R22 SERVICE BULLETIN SB-120A
(supersedes R22 Service Bulletin SB-120)

SUBJECT: Tail Rotor Blade Inspection and Replacement

EFFECTIVITY: P/N A029-2 tail rotor blade S/Ns 11279 and prior (A029-2 REV U and prior). Affected blades were factory-installed on R22 Helicopter S/Ns 4873 and prior.

SPECIAL TAIL ROTOR TIP PREFLIGHT INSPECTION

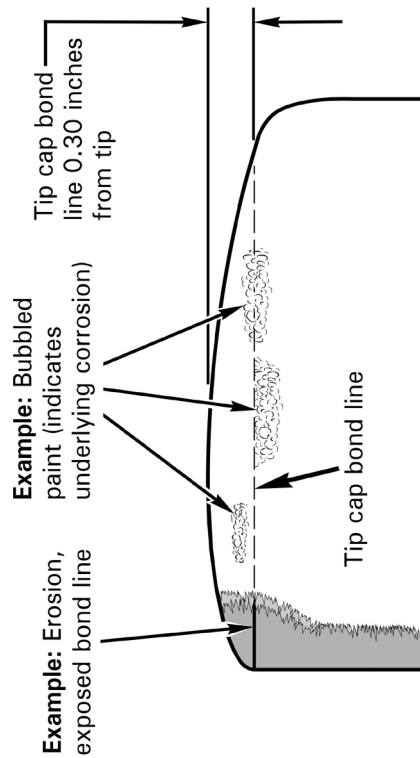
To be performed before the first flight of each day. May be performed by pilot or mechanic. Conduct visual inspection of tail rotor tip area. If bubbled paint or other evidence of corrosion is observed at or adjacent to tip cap bond line or if any portion of tip cap bond line is exposed, do not fly helicopter. Comply with latest revision of R22 SL-93 prior to further flight.
